STAFF REPORT

SPECIAL EXCEPTION APPLICATION SE 2014-PR-032 & 2232-P14-4

APPLICANT: Virginia Electric and Power Company,
d/b/a Dominion Virginia Power

LOCATION: 7701 and 7707 Shreve Road

Figure 6 Transitional Screening Plan

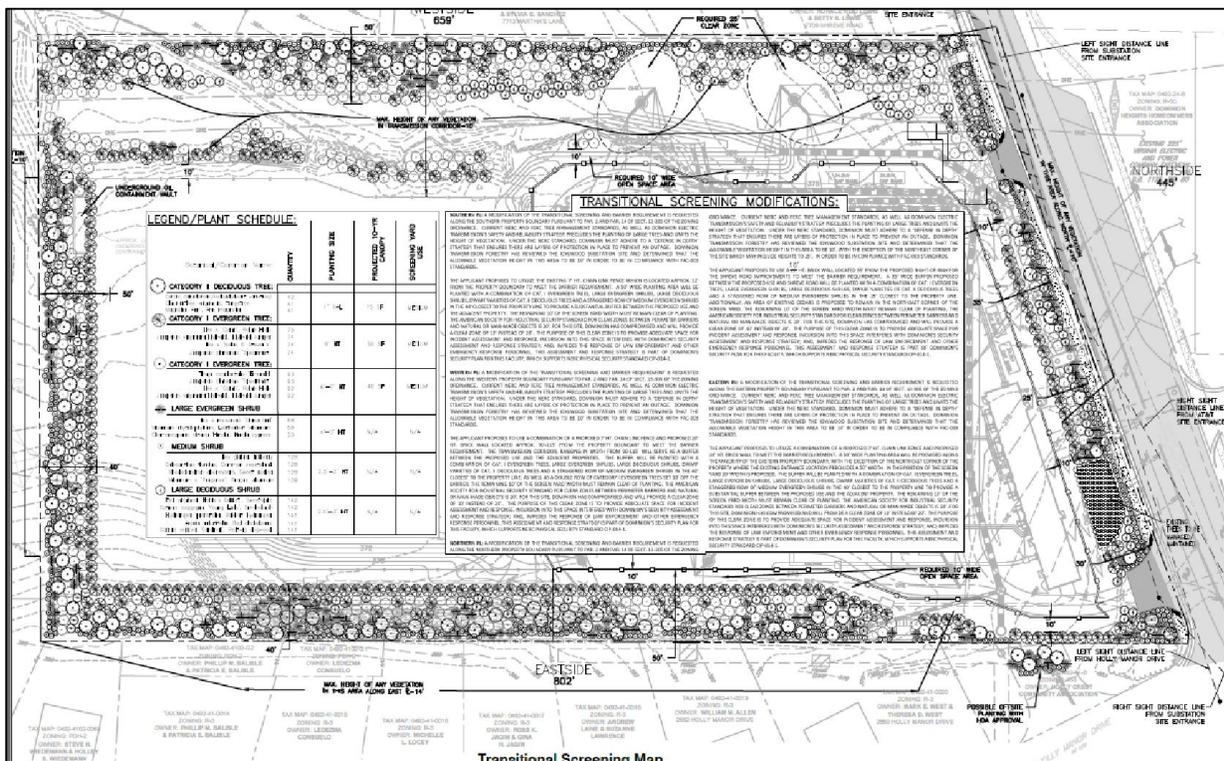
- 1. Comment:** The 35' identified as the required transitional screening yard width for the northern property line, as shown on sheet 13, is incorrect. A 50' wide transitional screening yard is required at the northern property line.

Figure 8 Eastern Elevation

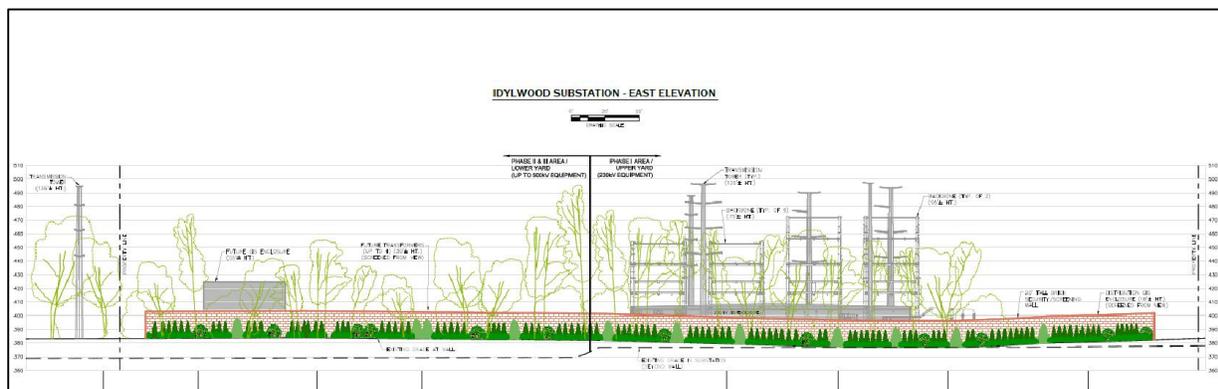
The applicant has shown renderings of the first years after the vegetation is removed and staff notes that there will be an interim landscape that will be starker than what the neighborhood has become accustomed to. However, once the proposed on and offsite screening reaches full maturity, staff believes that the site will be adequately buffered on all sides. The applicant has also committed to a masonry wall to help mitigate the visual impacts of the site as well. The proposed development conditions provide that the vegetation will be provided as shown on the SE Plat and in coordination with neighboring properties.

With the implementation of the proposed development conditions, staff finds that the landscape plan presented here is satisfactory.
